## Draft A.B. 2121 Instream Flow Policy: Framework Proposal for Defining Stream Management Objectives

McBain and Trush  
Trout Unlimited

April 30, 2008

Figure 1. Coho spawning habitat rating curve for Davenport Creek, Humboldt County.

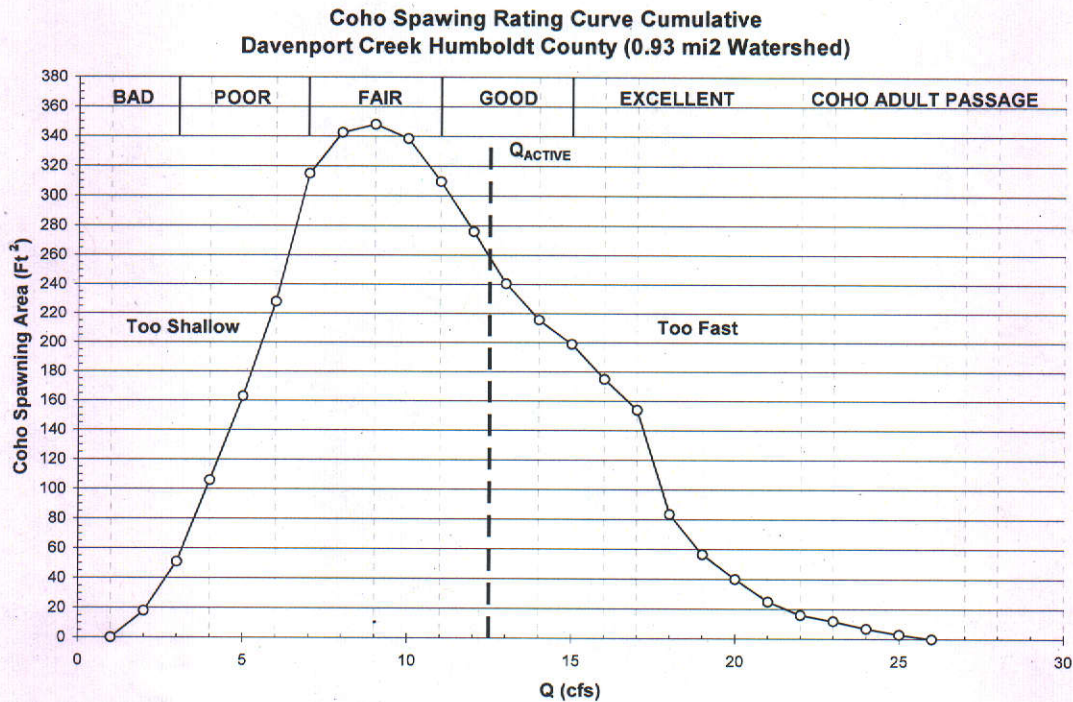
Results of the habitat mapping fieldwork are presented first as in a classic PHABSIM format, where total habitat area from the 10 sites is plotted as a function of streamflow (Figure 1). Using the terminology of Appendix E, the lowest streamflow at which 'maximum spawning habitat availability' occurred is at 9 cfs, though narrowly bracketed by 8 cfs and 10 cfs streamflows that provide extremely similar total Coho spawning areas.

Figure 1 is not too informative as to how spawning habitat availability relates to streamflow, and its interpretation can be misleading. Figure 2 decomposes Figure 1 into the 10 original spawning sites. The cluttered appearance of Figure 2 highlights the complexity of how channel morphology, streamflow, and fish behavior interact. The two biggest curves are for broad pool tails, where channel width is approximately 20% greater than the mean width. In contrast, the site with a pronounced platform at 17 cfs (spanning 7 cfs to 19 cfs) is a long, wide run with a lateral bar along its right bank. The three sites with steep, cone-shaped habitat rating curves peaking between 7 cfs and 9 cfs are short pool tails. Ongoing field monitoring is revealing that redds constructed in these short pool tails tend to

Figure 2. Coho spawning habitat rating curves for Davenport Creek, Humboldt County, for individual channel locations.

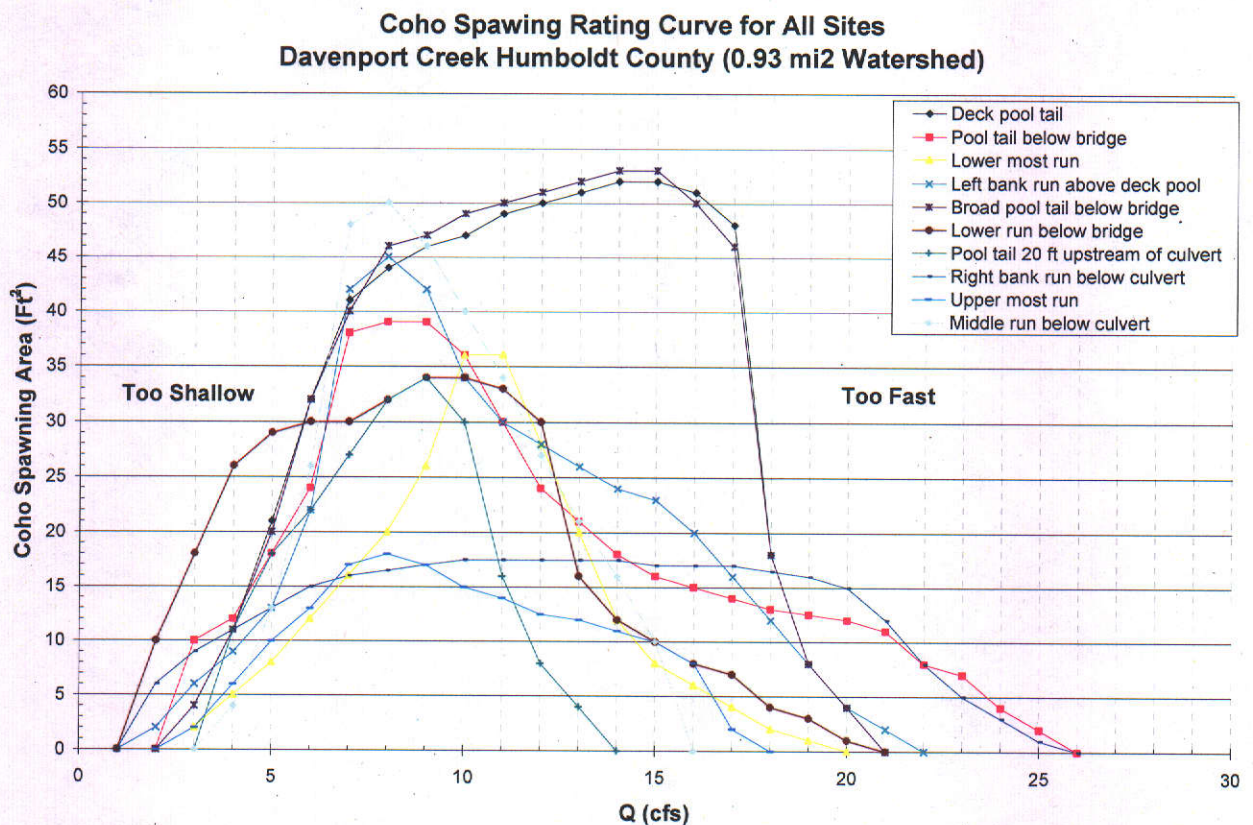
scour more easily and often during peak winter flows than redds constructed in the runs. Each spawning site offers a unique redd environment that may or may not promote success (fry emergence) depending on the magnitude, duration, frequency, and timing peak streamflows during egg incubation and alevin development. The clutter of individual habitat rating curves, therefore, offers risk management to coho salmon trusting their redds to an unpredictable future.

Spawning habitat availability, not shown on the habitat rating curve in Figure 1 or individual curves in Figure 2, requires consideration in space and time. The habitat a migrating coho adult will see first, on entering my segment of Davenport Creek shortly following a peak flow event, are those spawning habitats on the right side of Figure 2. If a female delays spawning for 0.5 days to 1.5 days, she will select a spawning site among habitats available at approximately 7 cfs to 10 cfs portrayed in Figure 2. There is nothing optimal about the 'optimum' streamflow (commonly ascribed to the peak habitat area in Figure 1 or in Appendix E) in a natural stream. Our goal in recommending a winter instream flow protocol for small Northcoast streams is to not diminish spawning opportunity and success for that female coho entering my segment of Davenport

Figure 3. Exceedence probabilities for the active channel streamflow as a function stream drainage area.

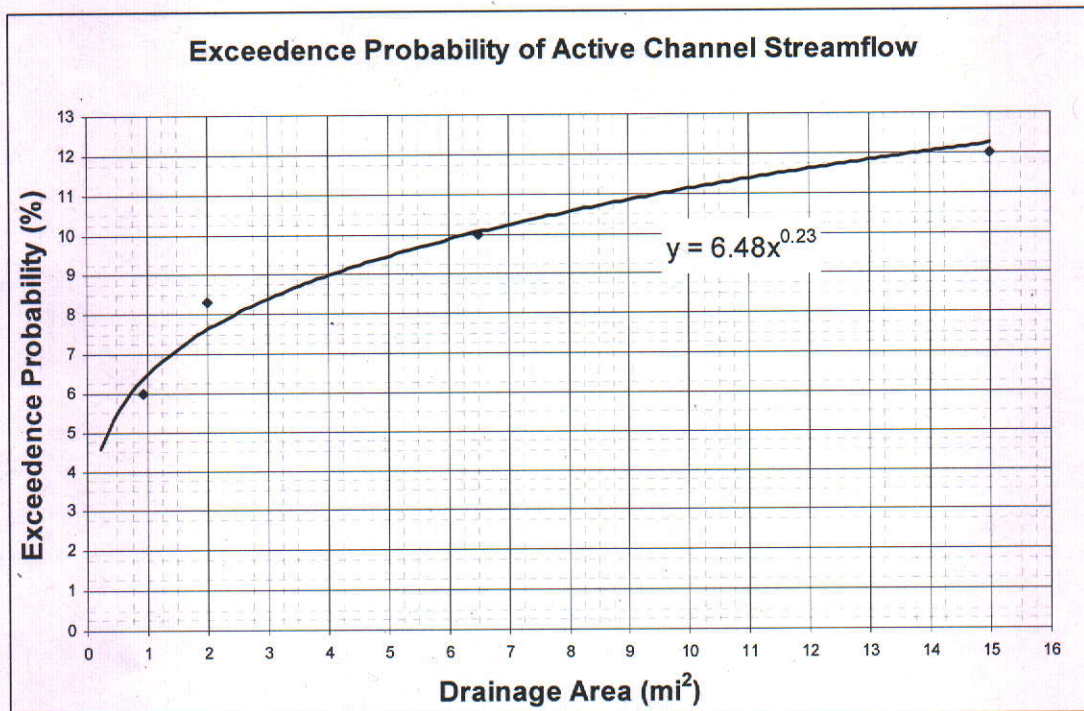
The streamflow that fills the active channel is an important geomorphic and ecological benchmark for anadromous salmonids. In the MTTU (2000) report, the exceedence probability for the active channel streamflow was assumed constant at  $p = 10\%$  over all drainage areas, but with the suspicion and some field evidence that the active channel streamflow in streams less than 5 mi<sup>2</sup> likely had smaller values of  $p$  (i.e., higher streamflows). Figure 3 is our latest estimate of the relationship between drainage area and the exceedence probability of the active channel streamflow. To protect spawning opportunity in small streams, streamflows equal to and less than the active channel stage must be explicitly considered in recommending any instream flow protocol.

Figure 4. WY1968 hydrograph for a 2.0 mi<sup>2</sup> tributary in the Mid-Russian River Watershed categorized by streamflow runoff with accompanying streamflow exceedences and thresholds.

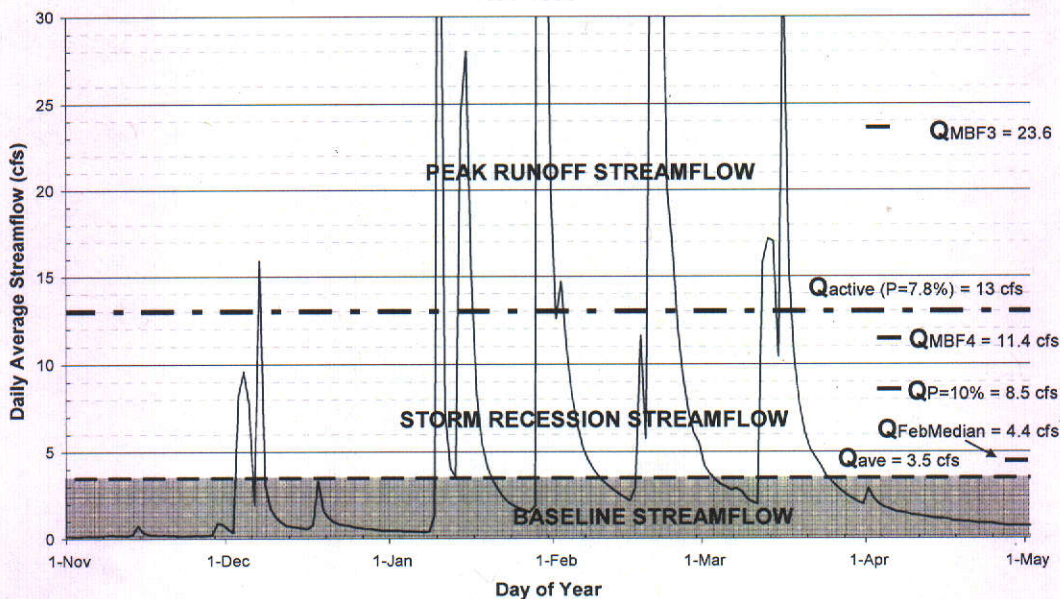
The annual hydrograph for a 2 mi<sup>2</sup> tributary watershed in the mid-Russian River Basin (Figure 4) was subdivided into three broad categories of streamflow and anadromous salmonid life history needs: (1) baseline streamflow that essentially keeps riffles flowing, sustains juvenile rearing habitat, and prevents redds from de-watering, (2) storm recession streamflow when most spawning occurs, and (3) peak runoff streamflow when the adults are actively migrating into headwater watersheds and some adults are beginning spawning activities. The same diversion rate for baseline, recession, and peak streamflows would have differing impacts to stream productivity and salmonid life history needs.

Note that there is a gray zone between Instream Flow Objective No.2 and Objective No. 3. Within the recession streamflows in Figure 4, an ambient streamflow reduction somewhere between 5% and 10% would likely produce a measurable reduction in spawning habitat opportunity, but may not compromise protectiveness (an hypothesis based on the Davenport data and the MTTU 2000 report). A diversion rate approaching 10% of the ambient unregulated streamflow likely would begin to compromise protectiveness but it still might not cause significant habitat reductions until reaching or exceeding a 20% diversion rate (particularly in the larger 'small' streams, i.e., greater than 5 mi<sup>2</sup>). Similarly, the gray zone between Instream Flow Objective No.2 and Objective No.3 within the peak streamflows in Figure 4 also warrants a similar caution.

Fixed diversion rates, however, can be formulated. For example, the diversion table in MTTU (2000, Figure 27) for the middle Russian could be applied to streamflows exceeding the active channel streamflow. For the WY1968 in Figure 4, the daily diversion rate would equal up to 2.6 cfs whenever streamflows exceeded the active channel streamflow of 13 cfs. This would require an intake at a stage height equivalent to 13 cfs, and would not reach the full fixed rate of 2.6 cfs until the streamflow reached 13 cfs + 2.6 cfs = 15.6 cfs.
